व्यावसायिक परीक्षण रिपोर्ट
COMMERCIAL TEST REPORT

संख्या / No.: Imp.207/279
माह / Month: February, 2017

**NEW SWAN ROTAVATOR, Model: NSML DT150 (Gear Drive)
(Tractor Operated)**

NORTH EASTERN REGION FARM MACHINERY TRAINING & TESTING INSTITUTE

Fig.1: SCHEMATIC VIEW OF NEW SWAN NSML DT 150 ROTAVATOR

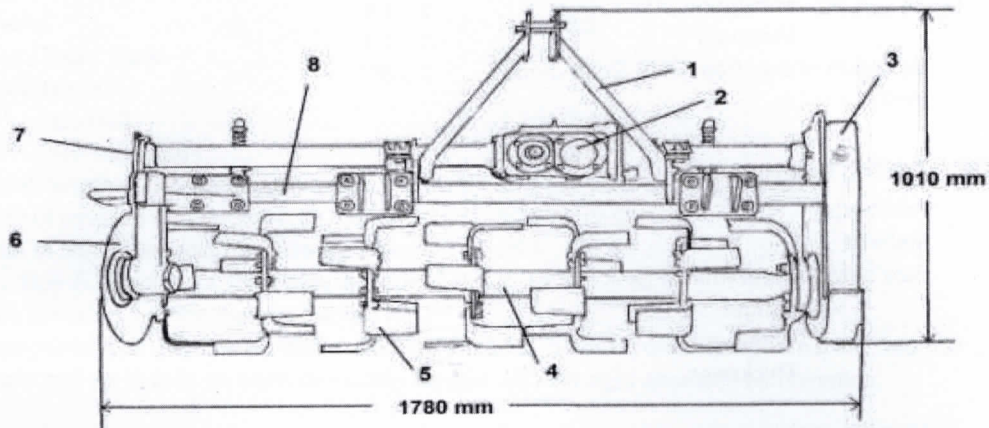
- 10.1** The dimensions of PIC yoke bore and PIC of the rotavator does not conform to IS:4931-1995. Hence, this should be looked into for corrective action for standardization.

- 10.2** The dimensions of three point linkage of the rotavator does not conform to IS: 4468-1997. Therefore, it is recommended to look into corrective action.

- 10.3** The hardness of blade at edge portion is not within its desired range as per IS: 6690-1981. Therefore, it is recommended to look into corrective action.

- 10.9** After completion of field test, it is been observed that the lubrication oil was contaminated with water in the primary reduction gear box of the rotavator due to poor quality oil sealings. Hence, it is recommended to look into the cause.

Para No.	Our reference	Applicant's Comments
11.1	10.1	For further production we shall take appropriate action to improve the same as per IS:4931-1995 in future.
11.2	10.2	For further production we shall take appropriate action to improve the same as per IS:4468-1997 in future.
11.3	10.3	Review the same ensure to comply the requirement of blade as per IS:6690-1981 in future.
11.4	10.8	As per recommendation of size & power on labeling plate we implement this in future production.
11.5	10.9	For further production we shall take appropriate action to improve the same.
11.6	10.10	Same is in process & we shall ensure to provide the same for further supplies both technical literature.
